## MEMORANDUM

Date: September 18, 2018

Subject: Amendments to the Kirkland Zoning Code and Comprehensive Plan for the Totem Lake Business District (File CAM18-00196)

Plate 34A 119th Avenue NE and NE 130th Place Street Improvements in TL 1A and TL 1B

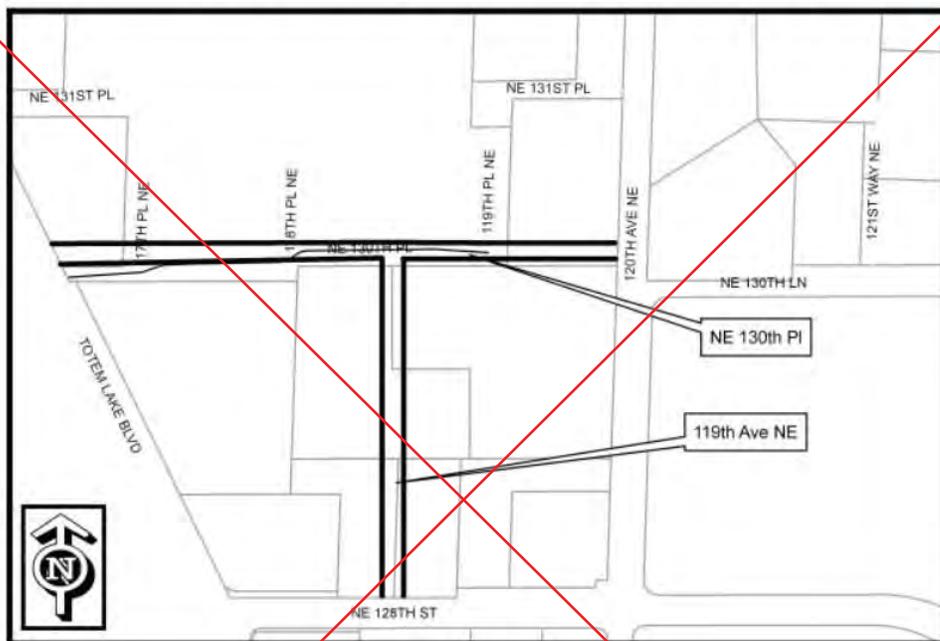
1. Consolidate Plates 34A, B, F and G into one map for Residential/Commercial Collector Streets – See revised plate 34A – Totem Lake Business District Street Improvements, and clarifications to concepts for 34F and 34G in Totem Lake design guidelines.

Plate 34C 118th Avenue NE Street Improvements in TL 10B Zone SHARE

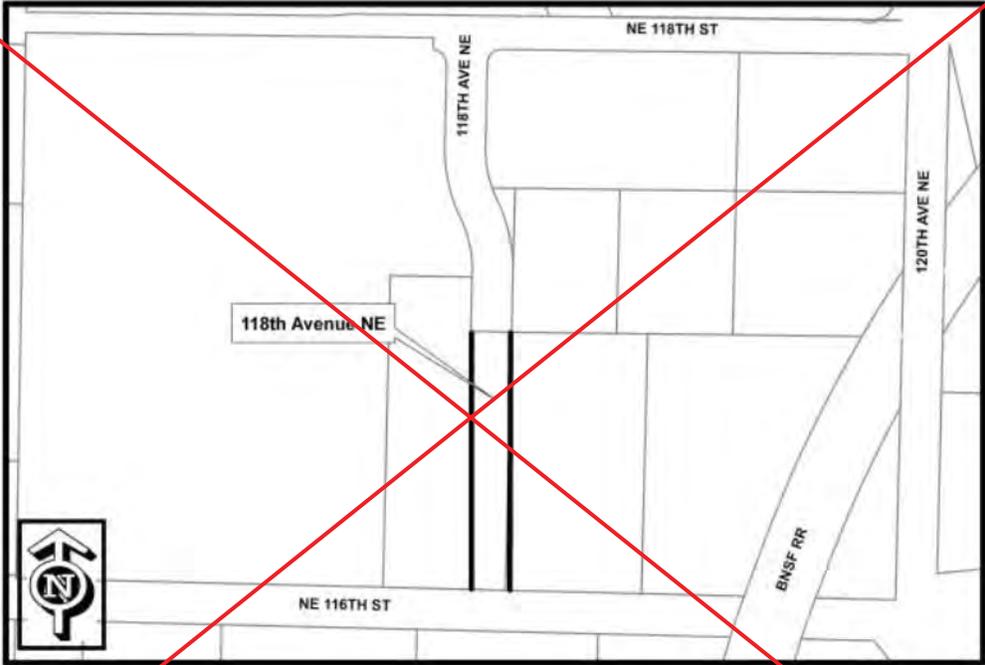
- 2. Eliminate Plate 34C. 118<sup>th</sup> Avenue NE is now under construction, associated with development of Lifebridge project in TL 10B.

# Plate 34-C

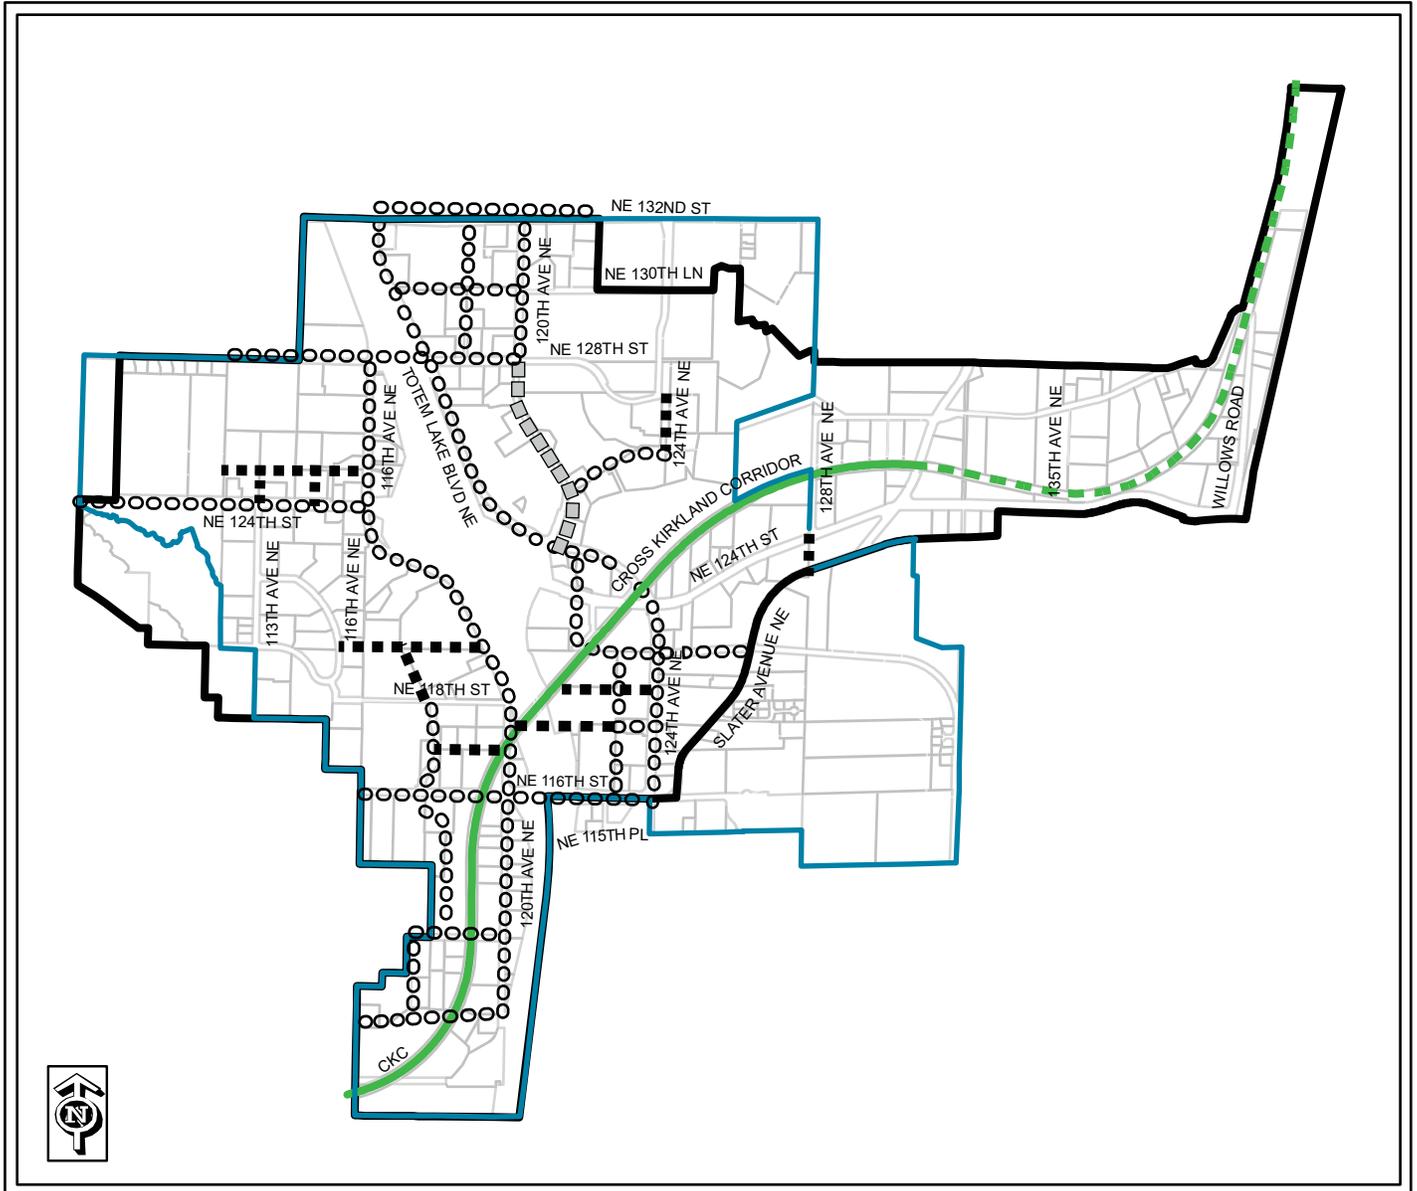
- Section 110.40: Addition of new type of collector street, called **the "Residential Commercial" collector street** (see Attachment 21).
- Chapter 180 (Plates): Revisions to Plates to:
  - Create new Plate 34A (see Attachment 22), to consolidate information from Plates 34A, 34B, 34F and 34G onto one plate (see Attachment 3).
  - Retain 34D, but rename as 34B (see Attachment 23).
  - Revise 34E, but rename as 34C (see Attachment 14).
  - Relocate conceptual information from Plates 34F and 34G to Totem Lake design guidelines.
